REMEDIATION SYSTEM EVALUATION

**BREWSTER WELL FIELD SUPERFUND SITE
BREWSTER, NEW YORK**

Report of the Remediation System Evaluation,
Site Visit Conducted at the
Brewster Well Field Superfund Site
October 30, 2001

Final Report Submitted to Region 2
April 8, 2002

FIGURE 1-2. PCE IN GROUNDWATER, NOVEMBER 2000.

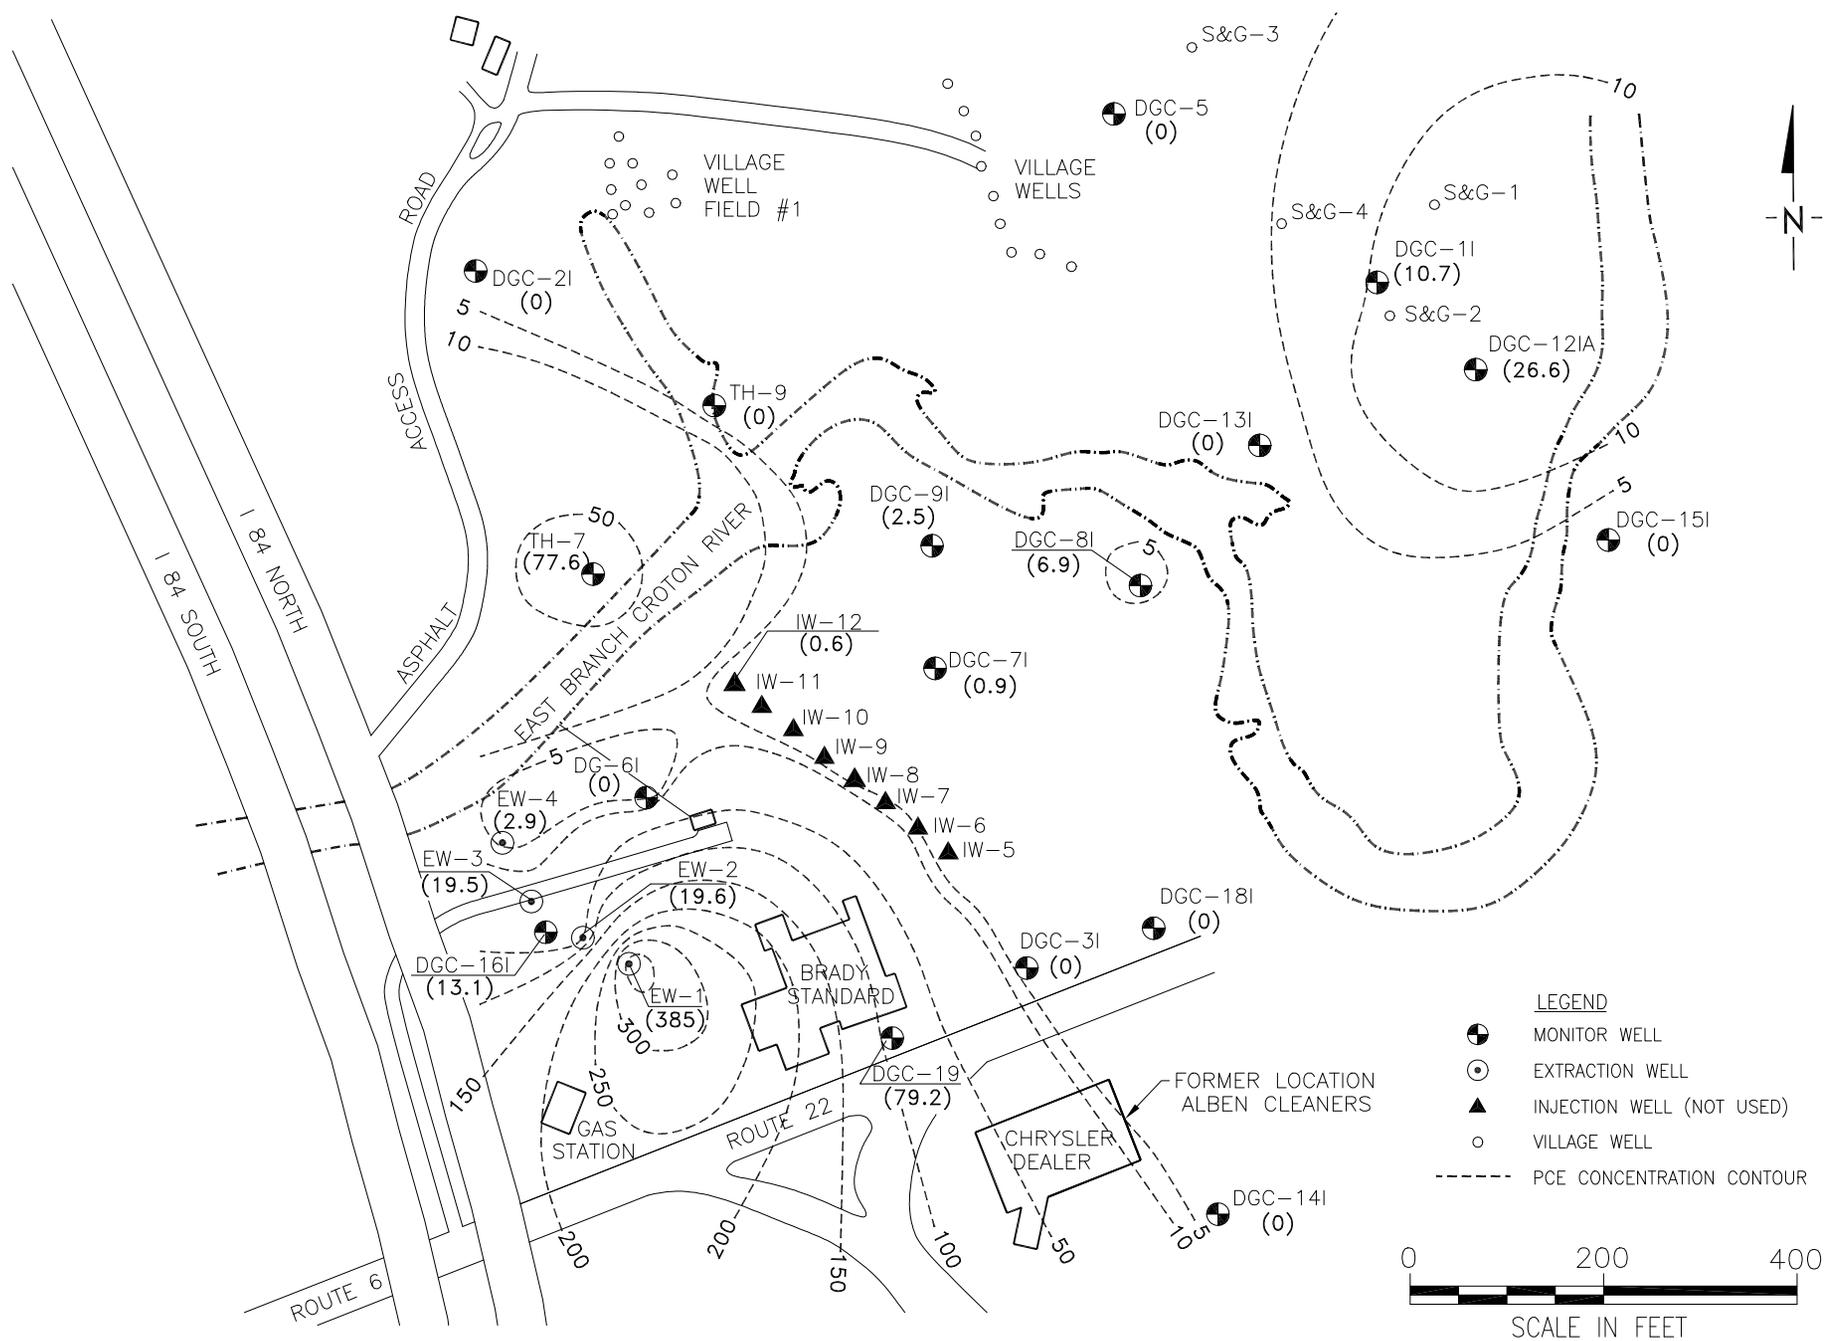
The PCE and cis-1,2-DCE maps are presented in Figure 1-2 and 1-3 of this RSE report. Selected observations from these figures include the following:

- Maximum concentrations of PCE are below 1000 ug/l, which is reduced from the 1979-1985 levels reported in the RI.
- Of the four extraction wells, only EW-1 is located in one of the areas with the highest PCE contamination onsite, while EW-2 through EW-4 are not.

- Impacts of PCE and cis-1,2-DCE are significant at TH-7, located north of the River.
- cis-1,2-DCE impacts are significant further to the east than the PCE plume (particularly DGC-7I).

- The current remediation wells (EW-1 to EW-4) are not located near TH-7 (north of the River) or DGC-7I (impacted by cis-1,2-DCE), or DGC-19 (impacted by PCE and cis-1,2-DCE).

- The extent of ground water contamination is unknown to the south (i.e., upgradient) of EW-1. DGC-19 is located directly between the former source and EW-1 and has concentrations of 79 ppb PCE and 211 ppb cis-1,2 DCE. No wells are located to the west of DGC-19 (south of EW-1) to delineate the extent of this contamination.

FIGURE 2-1. SHALLOW GROUNDWATER ELEVATIONS, SEPTEMBER 1999.

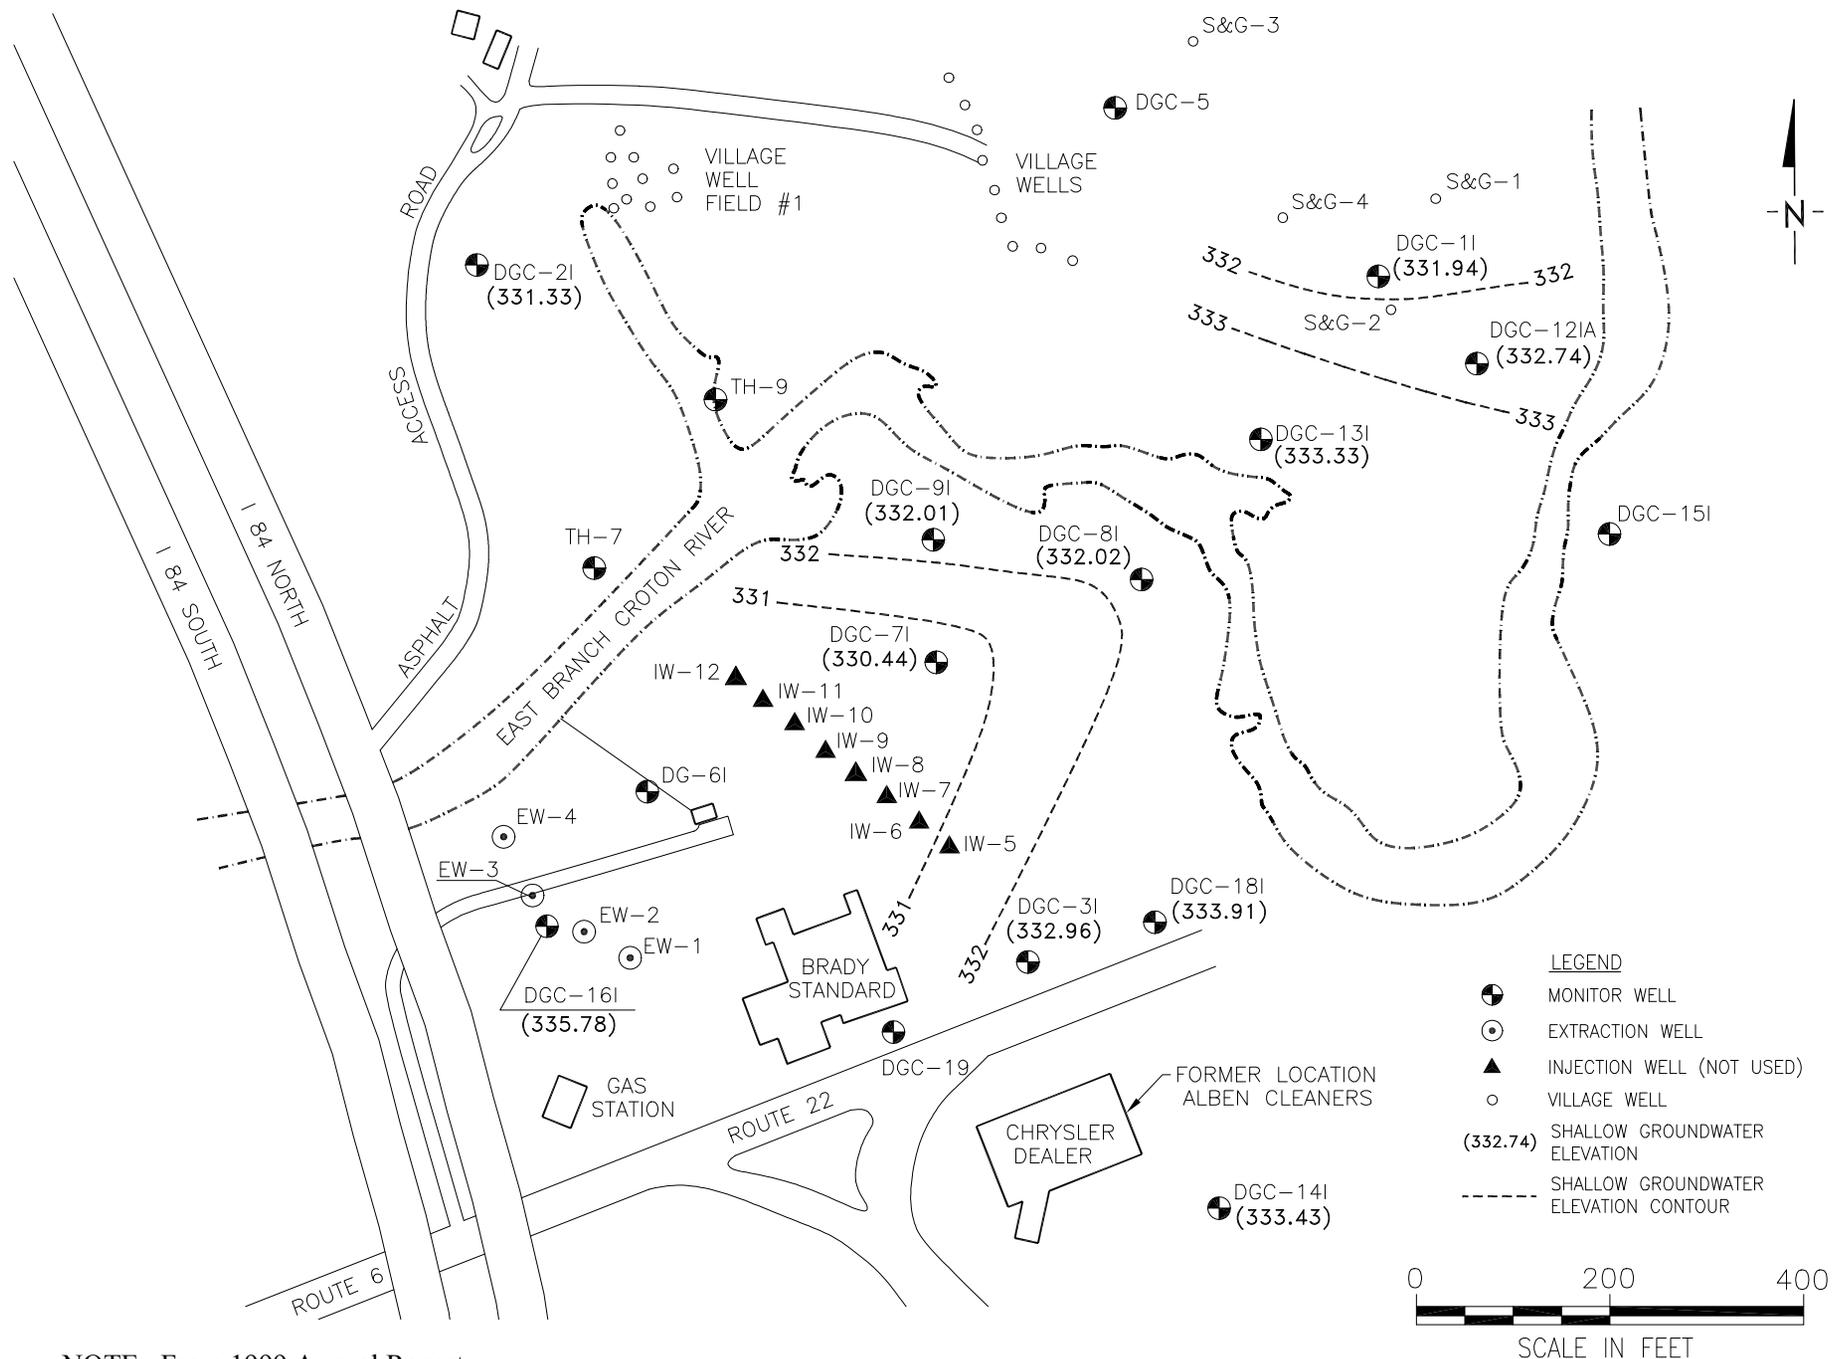
Also, the draft 2000 Annual report, does not include any presentation of water level maps from which flow directions can be interpreted. However, such maps were included in the draft 1999 Annual Report for shallow water levels (see Figure 2-1) and intermediate water levels (see Figure 2-2).

Figure 2-1, which pertains to the “shallow wells”, appears to indicate flow to the southwest, from the River towards the extraction wells (EW-1 to EW-4), but no water level measurements are available in the shallow zone directly north of the extraction wells. In the intermediate wells (Figure 2-2), however, ground water appears to flow towards the River to the northeast, except in the immediate vicinity of the extraction wells. In each case, the interpretation is severely limited by the number of measurement points, and interpretation of discharge into or out of the River is also limited by lack of river stage measurements.
